APPROVED MINUTES OF THE MEETING

October 16, 2008

1200 Stewart
Alaskan Way Viaduct – Battery Street Tunnel Upgrade
Shoreline Street End Master Plan
Alaskan Way Viaduct – South End
SDOT Art Plan

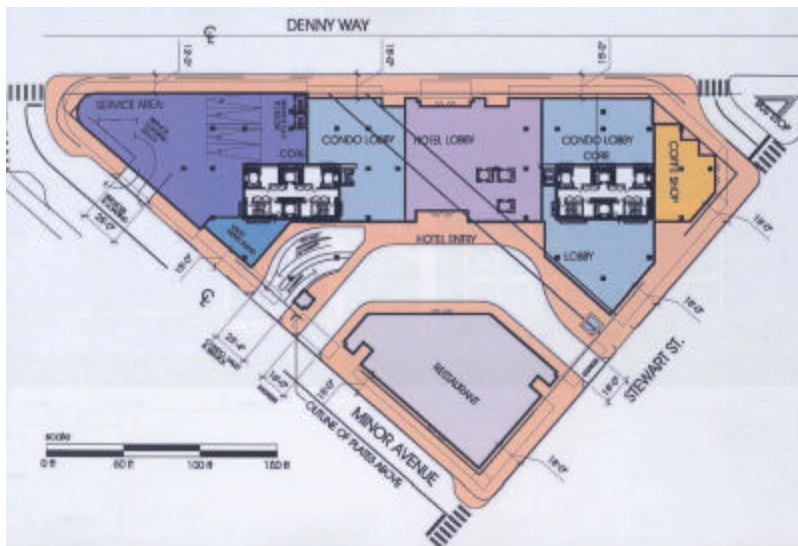
- In general, the sidewalk width and building setback is positive.
- There is one concern that the sidewalk width along the intersection of Denny Way and Minor Avenue, where the fifteen foot sidewalk is reduced to twelve feet. The Commission encourages the designers to provide a constant width along the property edge.

- There is greater concern at the corner of Denny and Minor about the approach of layering vegetation, the craftsman wall, the vent where canopy falls and the façade. The Commission recommends refining this design considering ventilation, noise, use of materials, scale and transparency and the human character of the corner.

- **The Commission recommends extending the pedestrian paving across the apron to expand the pedestrian realm.**
- **There are concerns about the designation of Minor Avenue as the neighborhood pedestrian street with all vehicle entrances and driveways. Suggests consolidating three curb cuts into two. Revise interior circulation.**

- **The treatment at Denny Way and Minor Avenue is inadequate for such a visible corner. Recommends revisiting.**
- **Consider incorporating the future pedestrian crossing on Denny Way towards Minor Avenue to the north into the design. While this is not defined, the design could consider some dimensions that will allow this to be incorporated in the future.**

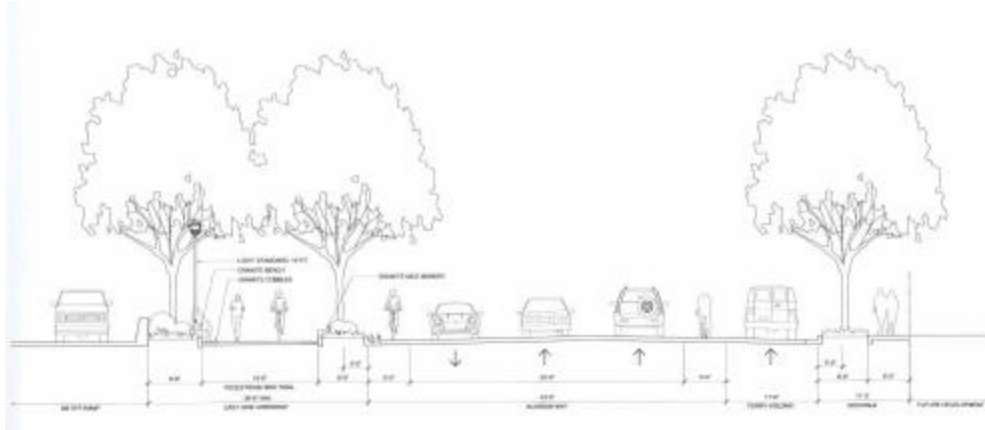
- Appreciates the clarity of design and adaptations to circumstances.
- Applauds the simplification of the landscape design, it reads more strongly.
- Questions design of space east of tail track; understands that thinking is in progress on this great opportunity. There are some safety concerns about “flip flopping” the east-west location of the track and trail.

- Recommends focusing on the west side trail as transitory cycling route and encouraging stopping points on the east trail.
- Questions about relations to the “Great Eight” viaduct alternatives. Encourages the team to keep focused and on track with them. Appreciates the continuous corridor focus.
